South Texas Project Electric Generating Station P.O. Box 289 Wadsworth, Texas 77483

July 15, 2014
NOC-AE-14003105
10 CFR 50.12
10 CFR 50.90

South Texas Project
Units 1 & 2
Docket Nos. STN 50-498, STN 50-499
Third Set of Responses to April, 2014, Requests for Additional Information
Regarding STP Risk-Informed GSI-191 Licensing Application
(TAC NOs MF2400 and MF2401)

Figure 1: Large break chemical head loss as a function of relative frequency (log scale)

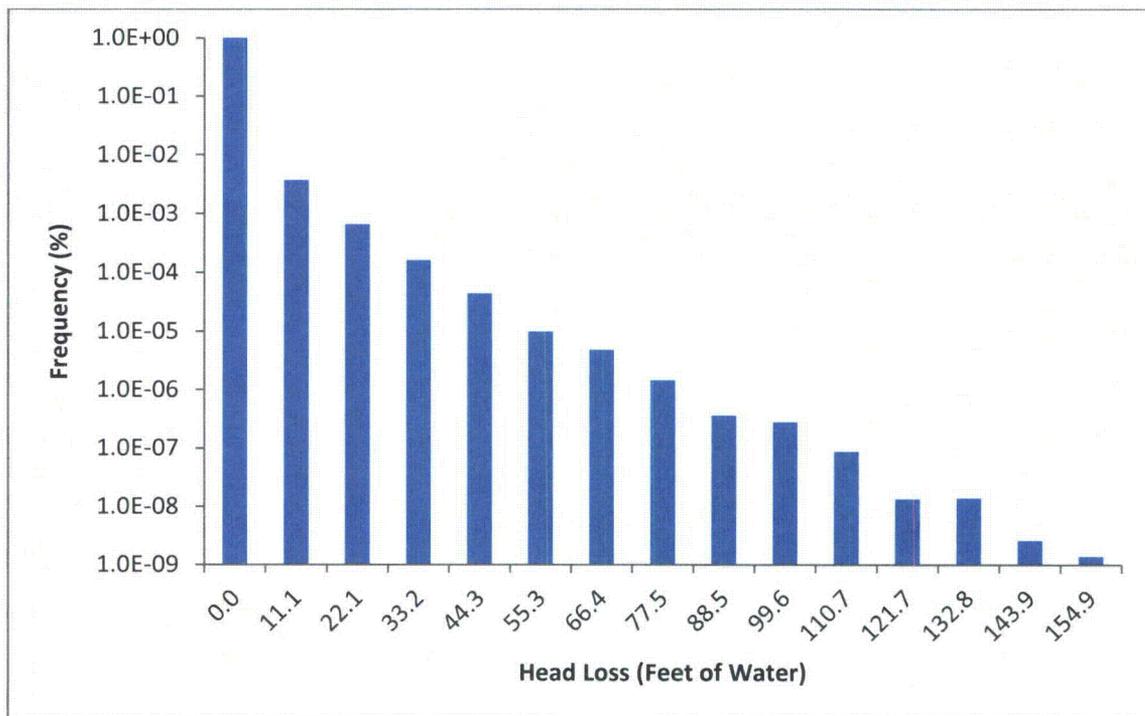
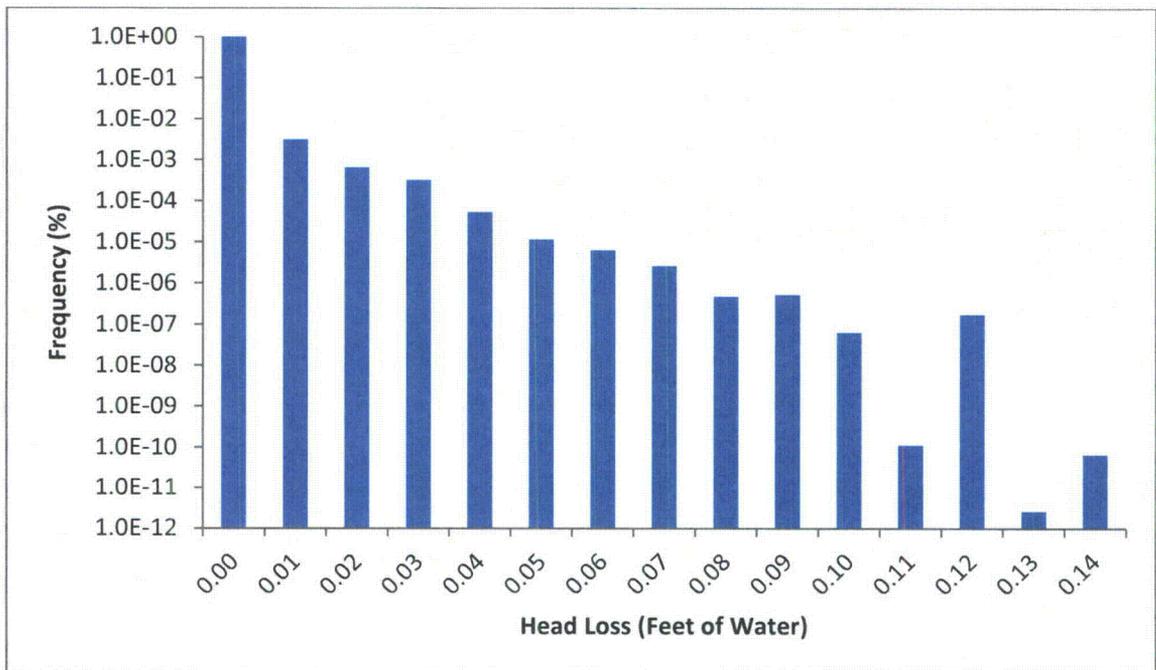
The exponential probability density functions (PDF) for small-, medium-, and large-break LOCAs (e.g., Figure 5.6.4, Volume 3) are shown in terms of a chemical bump-up factor. The NRC staff has questions related to the conventional (non-chemical) head loss correlation. The review of a chemical bump-up factor is complicated by the fact that it is essentially a multiplier on a parameter that is concurrently being reviewed for adequacy. Please provide the following additional information.

Histograms of chemical head loss vs frequency for CASA Grande Case 01 (all equipment operates) are presented by Figures 1 and 2. Of the large breaks analyzed in Case 01, only 77% formed a thin bed or larger and the resulting chemical head loss for all large breaks ranged between 0 and 154.9 ft as shown by Figure 1. Of the medium breaks analyzed in Case 01, 1.3% formed a thin bed or larger and the resulting chemical head loss for all medium breaks ranged between 0 and 0.14 ft as shown by Figure 2. Small break LOCA are not listed because none of the cases analyzed in CASA Grande Case 01 formed a thin bed or greater.
